**WEARE RESERVOIR DAM  
NH 00114**

**PHASE I INSPECTION REPORT  
NATIONAL DAM INSPECTION PROGRAM**

**AUGUST 1978**

## Earth Embankment:

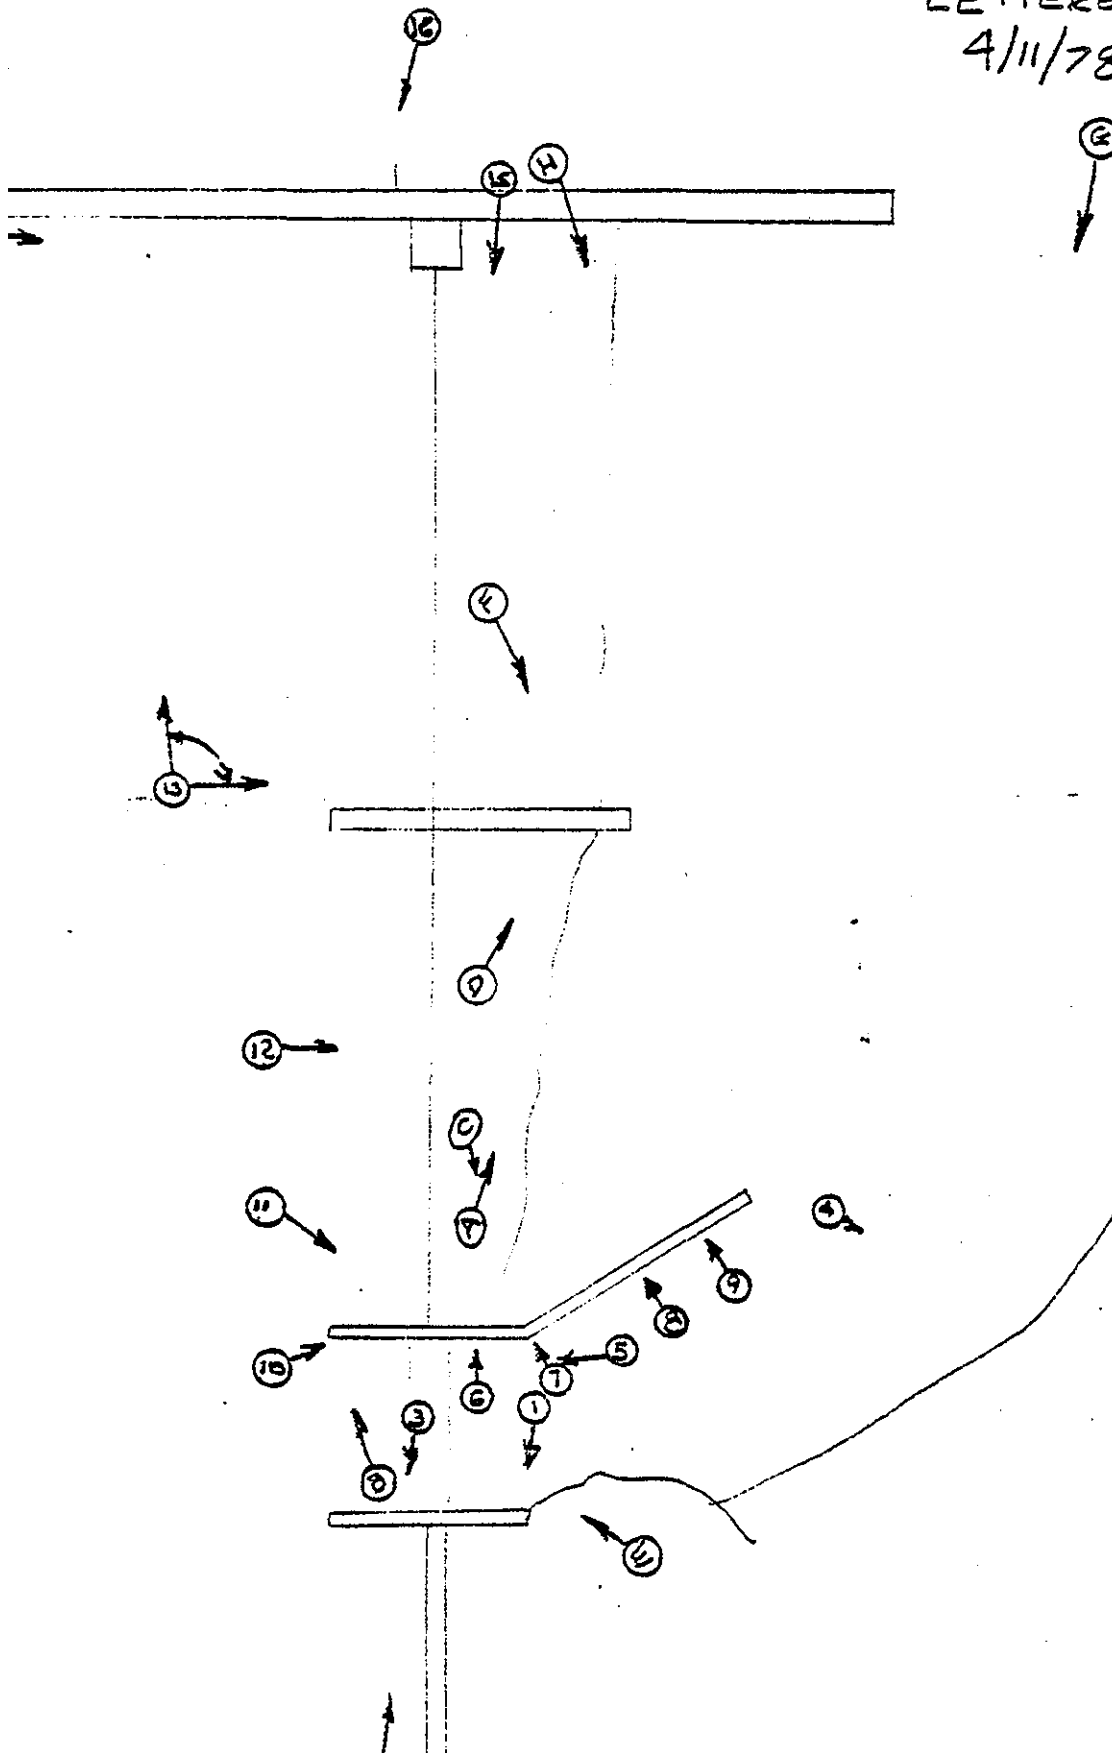
There are some areas near the North abutment that should be filled and covered loam and seeded. The downstream slope should be cleared of heavy growth.

LETTERED PHOTOS  
4/11/78

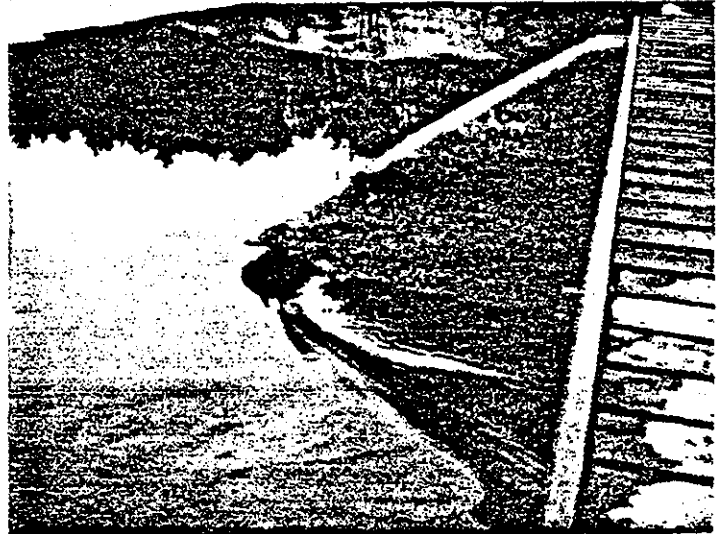
CRACKS

WATER FLOWING UNDER  
CONCRETE

SPALLING & LEACHING

Memo about upstream face - 11/21/63

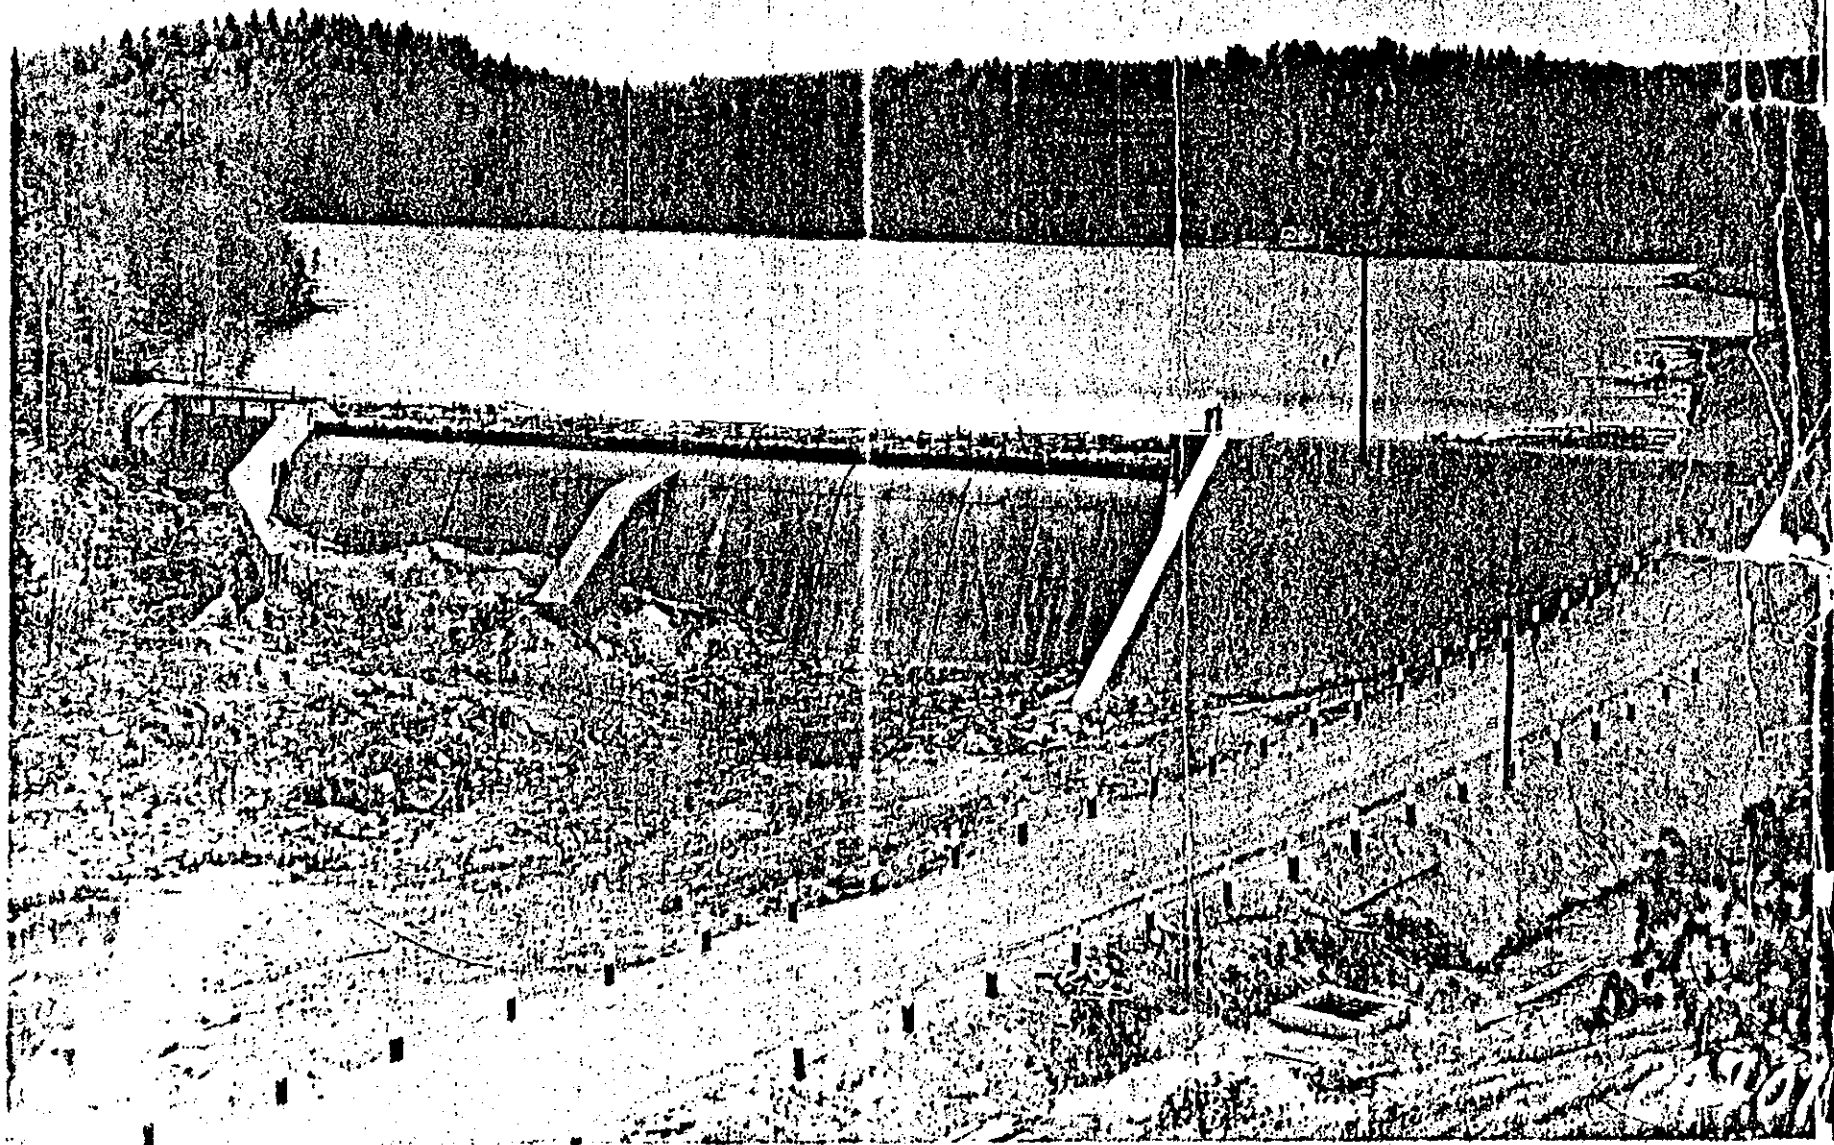
An inspection was made of the upstream face of Weare Reservoir Dam adjacent to the gate house on November 21, 1963. The area in question had been inspected in 1954 and photographs taken at that time showed scaling concrete about 16 feet below the crest running across this section.

During this inspection, it was noted that this original scaling area had not appeared to change in size or shape near the water surface at 13 feet below the crest. However, at the upper level of the dam 3 - 5' below the crest, the former small scaled areas have increased in size. This condition was probably caused by the action of ice at this level.

The extent of this scaling does not appear to have changed substantially in the past 9 years to warrant repairs.

It is recommended that these areas be checked regularly and if substantial changes are noted, the necessary repairs should be made.
